## Memorandum

Subject: Transportation Analysis Consistency Review for the Hotel Clariana Phase II

Residential Development Adjustments

Figure 3
Ground Floor Site Plan and Trips at Driveways

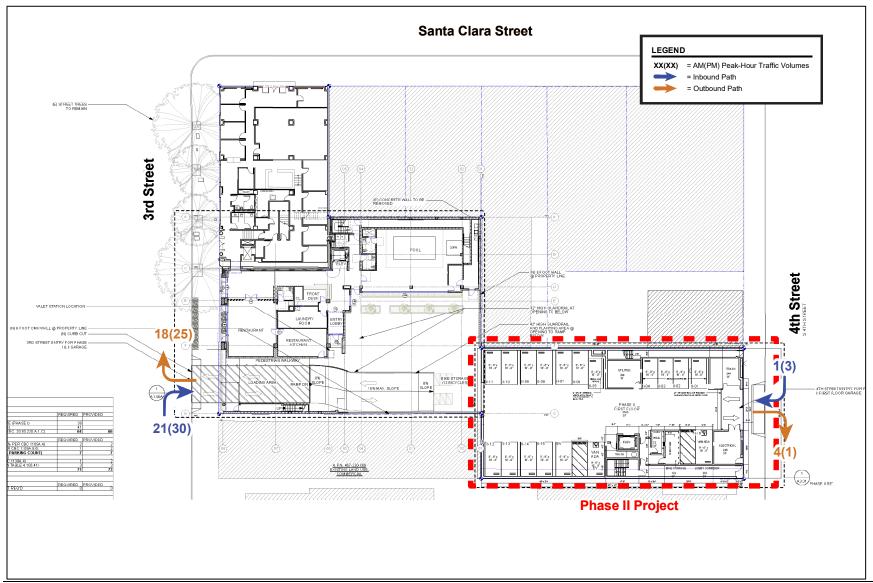
The revised site plan dated March 2022 (Figure 3) indicates no changes to the design of the project driveways along Third Street and Fourth Street. The Fourth Street driveway would provide access to a ground-floor parking lot serving the Phase II residential use. The Third Street driveway would provide access to a below-ground parking level located beneath the Phase I hotel and Phase II residential sites. Vehicular access between the ground level and basement level would not be provided on-site.

As discussed in the March 2021 LTA, drivers exiting from the Fourth Street driveway may have difficulty seeing southbound traffic if a tall truck obstructs the view of Fourth Street from the driveway. The recommendation from the LTA is provided below.

The gross project trip assignment at the proposed project driveways is shown in Figure 3.

Based on the estimated project trips, it is projected that a maximum of 22 and 33 inbound trips (during the AM peak-hour and PM peak-hours, respectively) would enter the parking garages. Based on the site plan, approximately 51% of residential parking spaces would be located within the basement parking level and accessible from Third Street, while the remaining 49% would be located within the ground-floor parking level and accessible from Fourth Street. Additionally, all hotel parking would be located within the basement parking level accessible from Third Street. The estimated inbound trips at each of the site's driveways for the residential (Phase II) and hotel components (Phase 1) are shown on Table 1. During the AM peak-hour, the Third Street driveway is projected to serve 21 inbound trips and the Fourth Street driveway is projected to serve 30 inbound trips and the Fourth Street driveway is projected to serve 30 inbound trips and the Fourth Street driveway is projected to serve 30 inbound trips and the Fourth Street driveway is projected to serve 30 inbound trips and the Fourth Street driveway is projected to serve 30 inbound trips and the Fourth Street driveway is projected to serve 30 inbound trips and the Fourth Street driveway is projected to serve 30 inbound trips and the Fourth Street driveway is projected to serve 30 inbound trips and the Fourth Street driveway is projected to serve 30 inbound trips.

As discussed in the March 2021 LTA, a vehicle that enters the Fourth Street driveway and waits for the gate to open would likely block a portion or all of the sidewalk width. The recommendation from the LTA is provided below.

**Recommendation:** There is an existing freight loading zone extending approximately 30 feet north of the existing Fourth Street driveway. Exiting drivers may have difficulty seeing southbound traffic if a tall truck obstructs the view of Fourth Street from the driveway. Proposed signage and striping changes along the Fourth Street project frontage would replace the freight loading zone with a single metered parking space, approximately 20 feet north of the driveway. The proposed improvement would help maintain an acceptable sight distance at the project driveway.

**Recommendation:** It is recommended that the Fourth Street entry gate be located further within the parking level to provide queuing space of at least one car-length (25 feet) between the gate and sidewalk.

Figure 4
Basement Site Plan

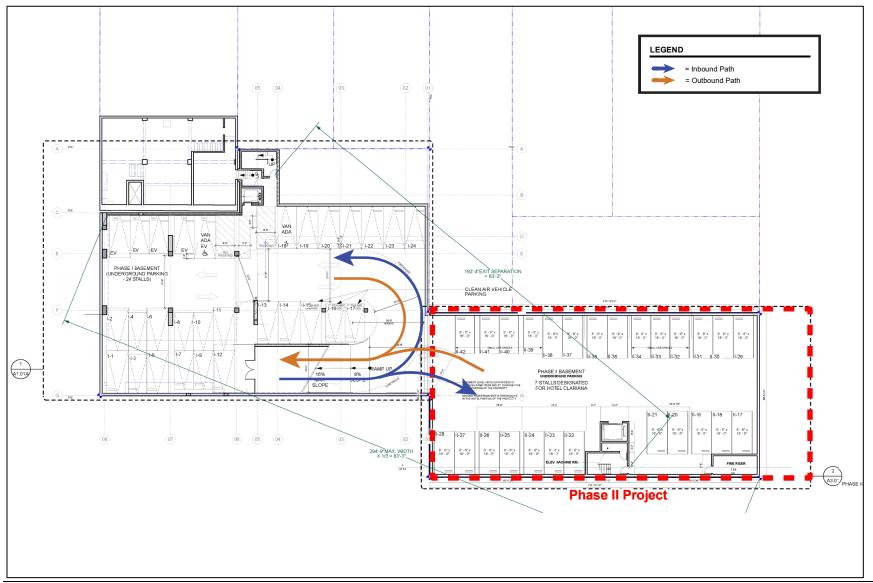
The project would provide 90-degree parking stalls within the parking garages. All drive aisles will need to meet the City's minimum width of 26 feet for two-way drive aisles. The site plan indicates that a majority of proposed drive aisle widths would not meet City standards including the following:

• Some of the two-way drive aisles serving 90-degree parking spaces are shown to be as narrow as 22 feet wide.

- The drive aisle that connects the Third Street driveway to the basement parking level is shown to be 20 feet wide.
- The access point between the Phase I basement and Phase II basement is shown to be 18 feet and 9 inches wide.

The drive aisle within the Phase I basement (shown on Figure 4) features a sharp turn at the base of the ramp. It is recommended that mirrors be provided along the outer radius of the sharp turn to provide incoming drivers a view of the parking stalls located adjacent to the sharp turn. Additionally, the access point between the Phase I basement and Phase II basement would connect at the described sharp turn. Due to the limited sight distance, it is recommended that stop signs be installed at the intersection of the two drive aisles.

There are dead-end drive aisles located on both parking levels. Dead-end aisles are undesirable because drivers may enter the aisle, and upon discovering that there is no available parking, will be required to back out or conduct three-point turns. Reversing out of these dead-end aisles could be challenging if all parking spaces adjacent to the dead-end are occupied. However, dead-ends should not be problematic since all hotel parking will be assigned to guests, as described below. It is recommended that residential parking also be pre-assigned to prevent residents from entering when the garage is full. The recommendations from the LTA are provided below.

**Recommendation:** It is recommended that mirrors be provided along the outer radius of the sharp turn within the basement parking level to provide incoming drivers a view of the parking stalls located adjacent to the sharp turn.

**Recommendation:** Due to the limited sight distance, it is recommended that stop signs be installed at the intersection where the Phase I and Phase II basements are connected.

**Recommendation:** It is recommended that residential parking also be pre-assigned to prevent residents from entering when the garage is full.
